9.3 Process Auxiliaries

The information in this section of the reference ABWR DCD, including all subsections, tables, and figures, is incorporated by reference with the following departures and supplements.

Figure 9.3-10 Breathing Air System Flow Diagram

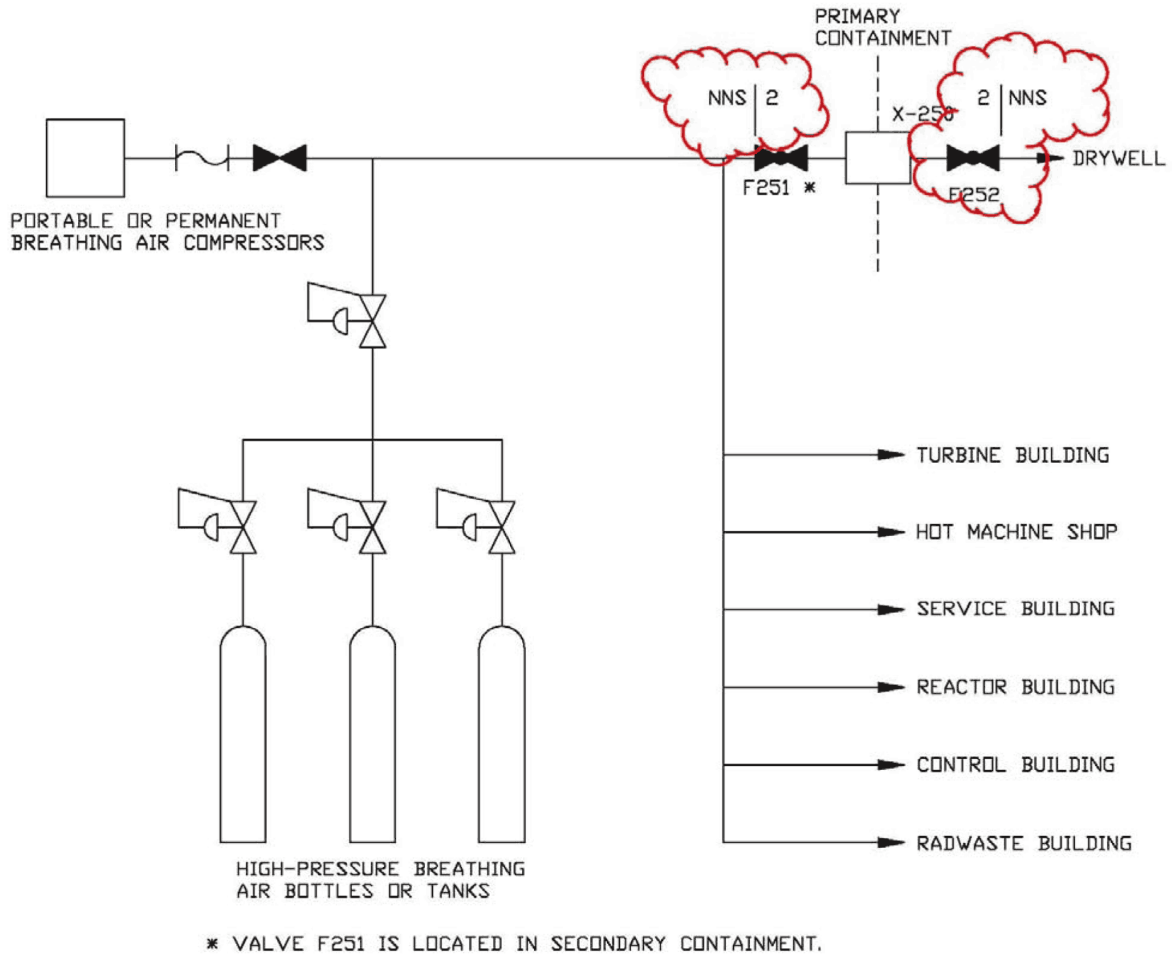
The BAS is sized to provide 100% of the peak air consumption using the bottled breathing air supply and a portable permanent breathing air compressor supply system, as needed. The compressor(s) will be of the oil-less, breathing air type.

The BAS flow diagram is shown in Figure 9.3-10.

<u>Pressure (design of BAS)</u>	<u>689 kPaG</u>
<u>Pressure (design of self-contained breathing apparatus charging)</u>	<u>17.23 MPaG</u>
<u>ANSI Compressed Gas Association (CGA) 7.1-1997, "Commodity Specification for Air"</u>	<u>Air Quality Grade D</u>

Figure 9.3-12 Non-Radioactive Drainage System

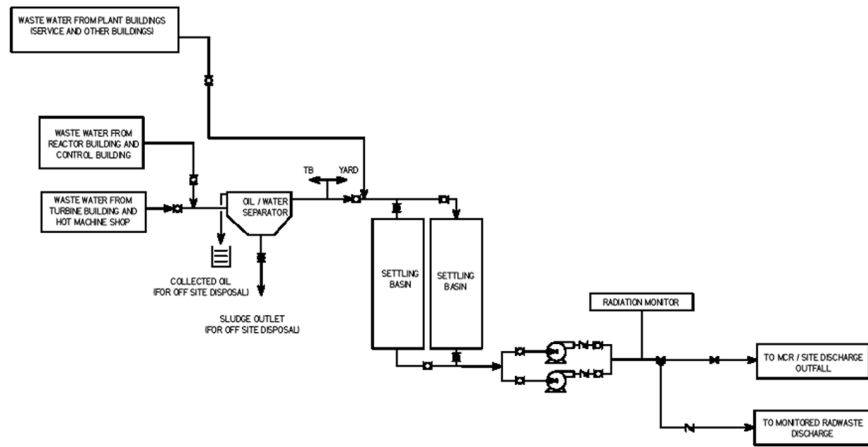
The design of the continuation of the non-radioactive drain system from the ABWR Standard Plant Buildings to the site discharge outfall is provided in Figure 9.3-12 and is discussed in this subsection.

The conceptual design information in this subsection of the reference ABWR DCD is replaced with the following site-specific supplement.
